PARAJET TECHNICAL ADVISORY BULLETIN

OCTOBER 2022 - UPRATED FUEL CAP REPLACEMENT

PJ-P-10088 : Fuel Tank Cap

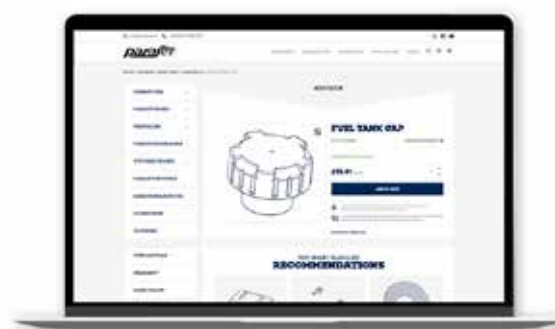
Parajet are aware of an extremely small number of cases where the fuel cap has not allowed sufficient air to enter the tank during use, creating a vacuum inside the tank and starving the engine of fuel.

All fuel tanks are prone to expansion and contraction as the volume of fuel within them changes. This is predominantly due to a temperature increase of the fuel which causes expansion and takes up a greater volume, or whilst fuel is being consumed, and less fuel remains in the tank over time.

Repeated exposure to excessive pressurisation without correct ventilation can lead to tank degradation, including deformation, splits, and tank ruptures.

An investigation was opened and following an immediate full batch inspection and review, our design engineers identified the OEM valve component at fault and have issued an in-house upgrade to better allow airflow to be drawn into the fuel tank at the optimum rate, avoiding vacuum build-up and fuel starvation to the engine.

This updated fuel cap is a direct replacement and should be immediately fitted to the tank and the old cap discarded.
